MARTIN COUNTY, FLORIDA DEVELOPMENT REVIEW STAFF REPORT

HOBE SOUND VILLAGE DUPLEXES MINOR FINAL SITE PLAN

Applicant/Property Owner	Palm Beach Capital Consultants, LLC, Matt Basaraba
Agent for the Applicant:	HJA Design Studio, LLC, Erika Beitler
County Project Coordinator:	John Sinnott, Senior Planner
Growth Management Director:	Paul Schilling
Project Number:	H094-012
Record Number:	DEV2023070005
Report Number:	2024_0625_H094-012_Staff_Report_Final
Application Received:	08/04/2023
Transmitted:	08/08/2023
Date of Report:	01/04/2024
Application Received:	05/29/2024
Transmitted:	06/03/2024
Date of Report:	06/25/2024

LEGAL DESCRIPTION EXHIBIT "B"

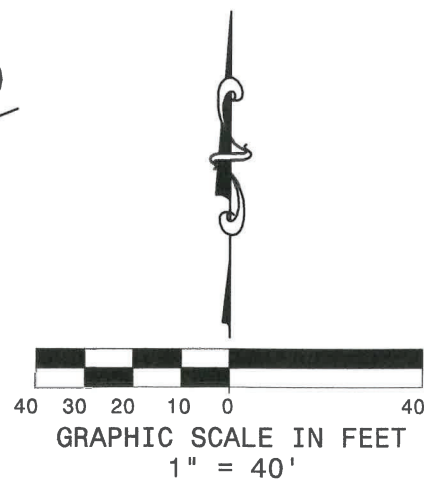
ADD ROW WIDTH
& RECORDED
INFORMATION

REVISE TO 10' WIDE

ADD PCN: 343842000195000606

ADD SQFT

REVISE TO 10' WIDE

SPELL OUT DIRECTIONAL
CALLS. (TYPICAL)

MISSING BEARING BASIS AND REFERENCE STATEMENT. MISSING
BEARING BASIS AND REFERENCE LABEL ON SKETCH.
